#### CHARNWOOD BOROUGH COUNCIL -CONSERVATION & LANDSCAPE

APPLICATION NUMBER: P/20/2380/2

LOCATION Barkby Road, Queniborough

PROPOSAL: Outline application for up to 150 dwellings, together with new open space, landscaping and drainage infrastructure, with all matters reserved accept for access

#### **TREES**

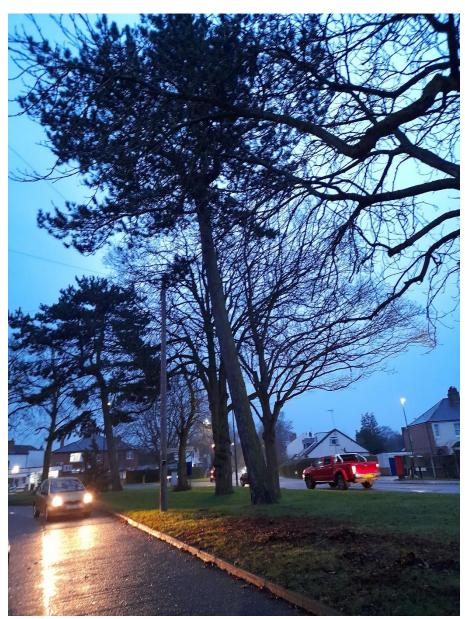
The proposed highway improvements to the cross road junction of Rearsby Road and Queniborough Road would slice through the existing verges which form the root supporting environment of trees protected by Borough of Charnwood Tree Preservation Order (Land at Rearsby Road/Queniborough Road, Queniborough) 2015, Group G1. Species include sycamore, pine, lime, horse chestnut, maple, robinia and whitebeam. The quality and nature of the tree lined verge needs to be preserved as an essential landscape feature of the main cross road of the village. However, there was no tree survey or arboricultural method statement submitted to support the proposed junction re-alignment. The indicative retention of some of the trees is therefore in doubt without evidence to demonstrate that the trees could feasibly be retained in a healthy form to protect their long term viability. Approximately six trees could be affected. Loss of trees at this junction would be highly noticeable disrupting the cadence of trees on The Ringway verge trees are iconic along Rearsby Road and Queniborough Road.

The adverse effect of their removal post-completion would be significant. Any losses could be mitigated by replacement planting which would reduce the adverse effect in the long term e.g. from approx. year 20 onwards. Early significant adverse effect could be further mitigated were semi mature specimens to be used for replacement tree planting. In such a scenario I would suggest fewer trees could be replanted to allow for good distinct canopy formation.

The proposed junction realignment is likely to require the reduction in levels to that of the existing carriageway. This would substantially impact RPAs of several trees.

The proposed realigned footpath would likely impact trees such as the pine on this side as it would require the reduction in levels.

Agreement would be required with LCC on suitable course of action and if any trees are lost, their CAVAT value is likely to be payable by the developer as well as replacement planting.
